هيئة تنظيم الاتصالات
Telecommunications Regulatory Authority

Position Statement on the BULRIC Models for mobile and fixed networks

January 2015

Exhibit 2.1: Graphical representation of the area covered by a site. Note: The three colored hexagons represent the three sectors covered by the plotted site

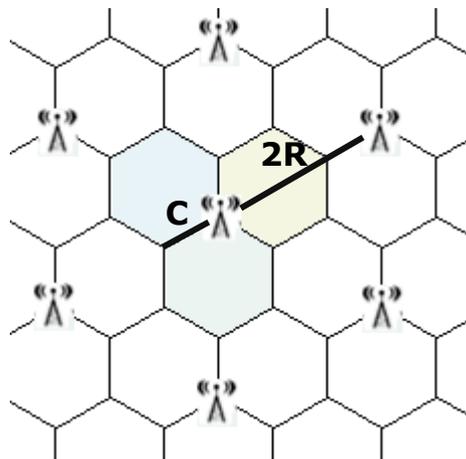
Additionally, Nawras is of the opinion that the formula employed for calculating the area of a hexagon is not accurate.

Finally, regarding Nawras' contribution on the formulae employed for calculating the area of a hexagon, it is important to bear in mind the definition of the parameters employed in the calculation of the maximum area of a cell.

In this regard, it is known that the area of a regular hexagon corresponds to the following formulae, where C represents any of the sides of the hexagon under analysis:

On the other hand, R represents the coverage radii of a site, which is calculated as half of the average distance between two adjacent sites, as detailed in the exhibit below:

When using tri-sectorial sites, the distance between two sites (2R) is equal to 3 times the side of the hexagon. Therefore, the side (C) is equal to 2/3 of the coverage radii; R. Accordingly, the formula applied, under the definition of the parameters given in this point, is presented below:

Therefore, the TRA concludes that the formulae employed for calculating the maximum area covered by a site is correct.
